Friday, February 6, 2026
Addendum #2

**HOLLY SPRINGS LIBRARY HVAC REPLACEMENT
(RFB #26-007)**

Sheet M502 – MECHANICAL DETAILS

3 ELECTRICAL CONNECTION TO MECHANICAL EQUIPMENT DETAIL

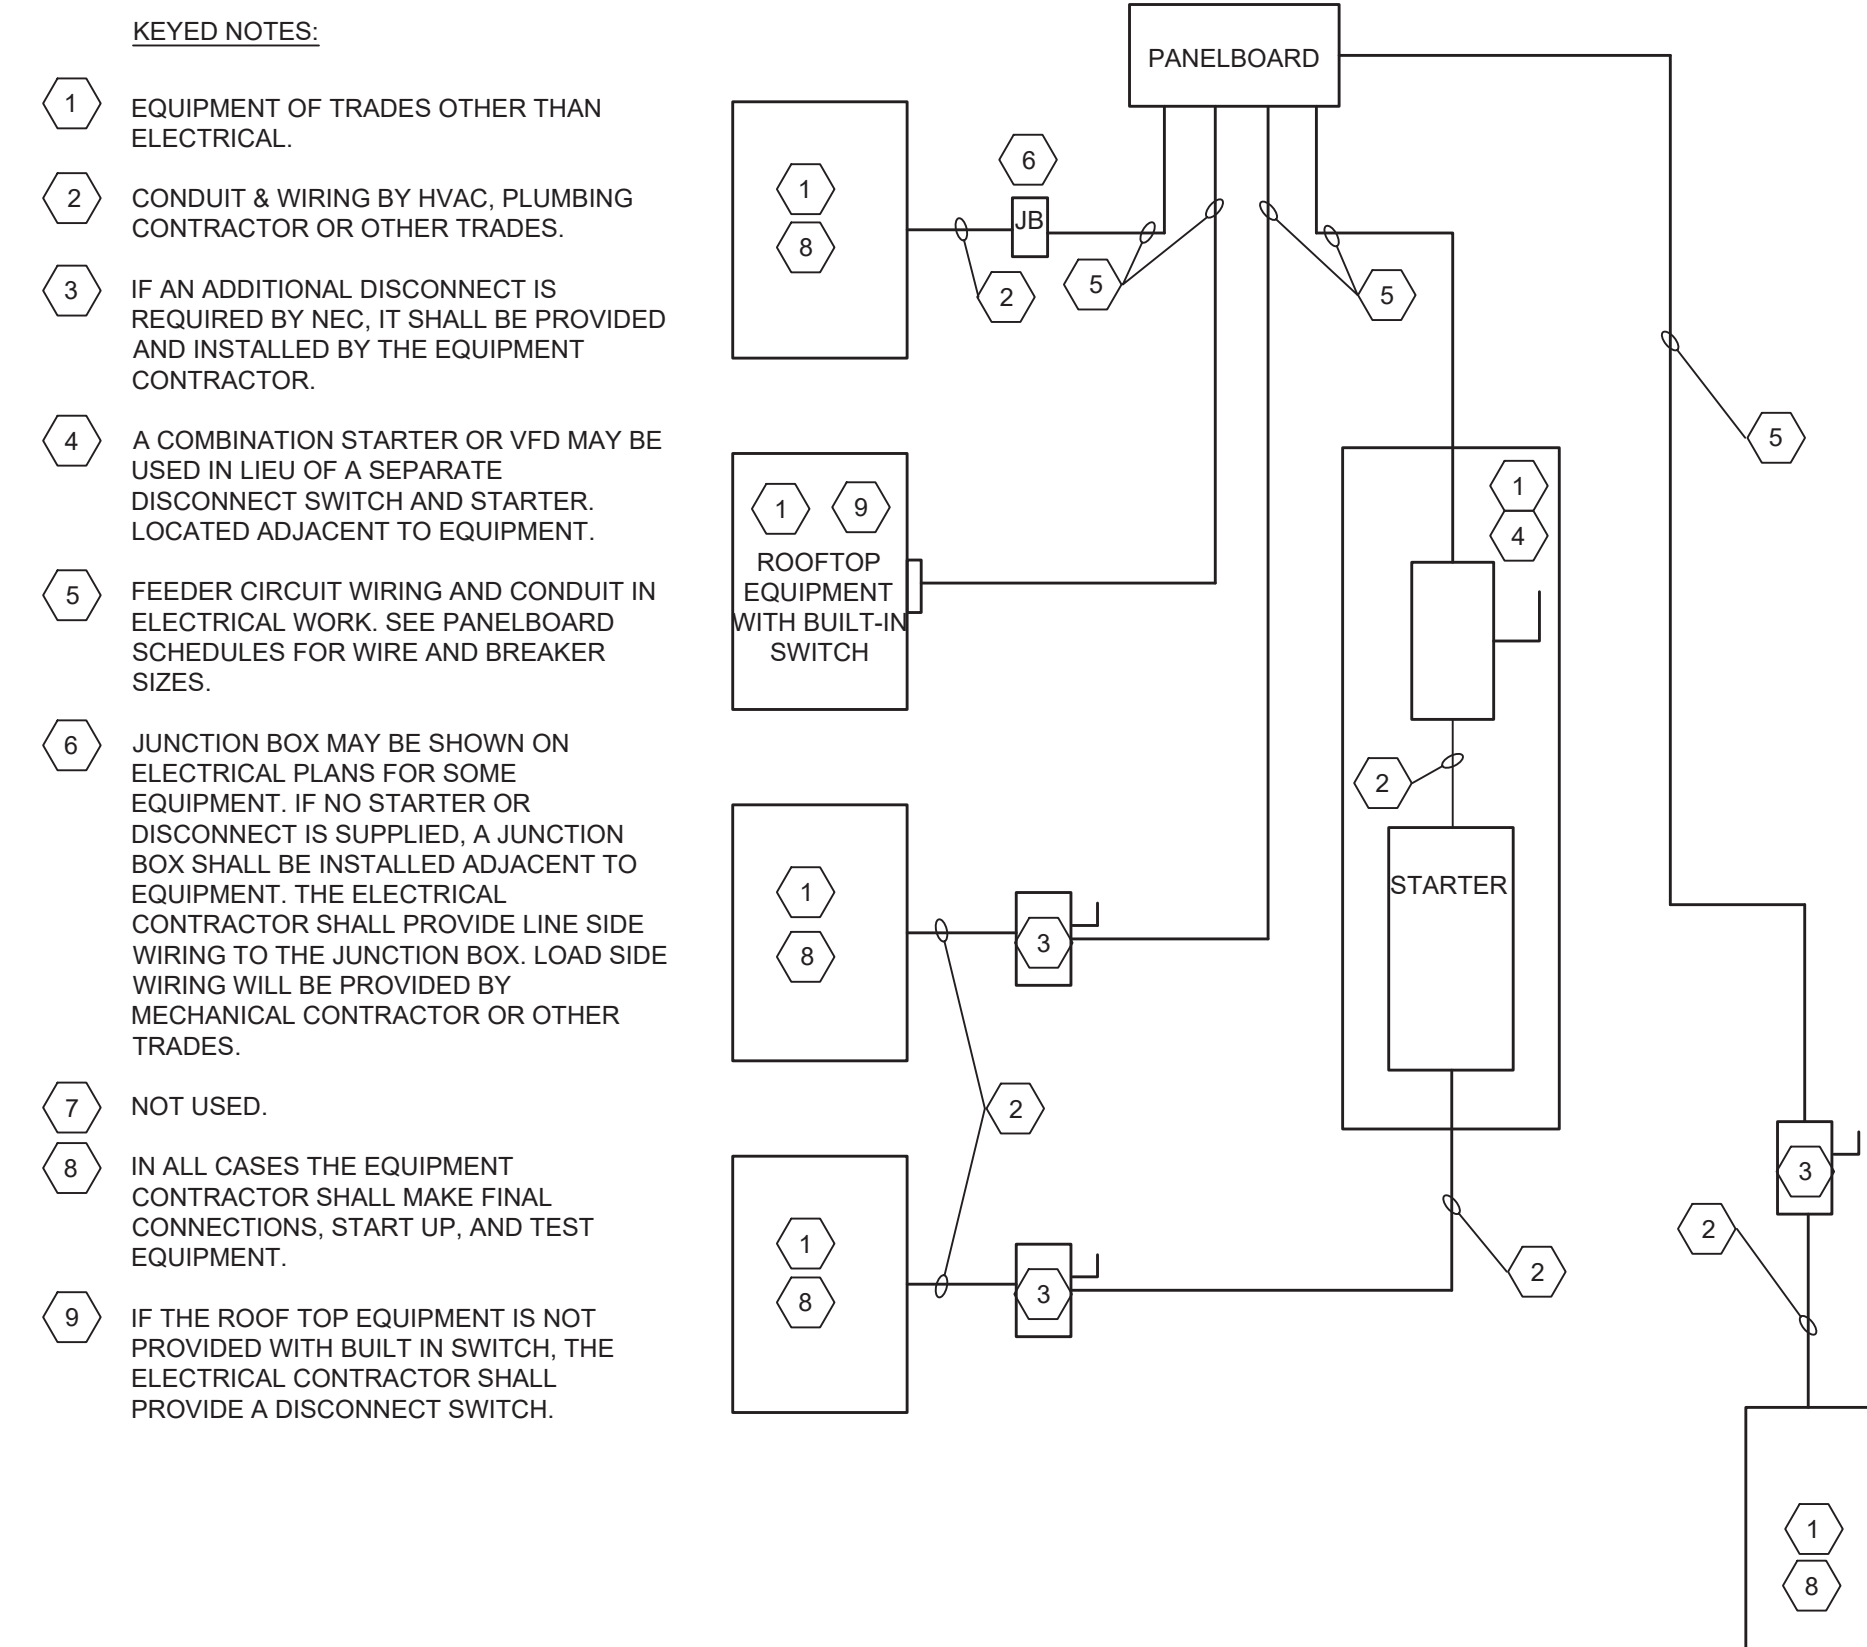
- a) Sheet M502 – Added detail 3 for electrical connections to mechanical equipment.

- a) **Q:** Who is responsible for load side connections, specifically for the chiller?

A: *Final connections to mechanical equipment are the responsibility of division 23 but must be carried out by a licensed electrical contractor. Divisions 23 and 26 should coordinate per detail 4/E500 and the added detail 3/M502 attached.*
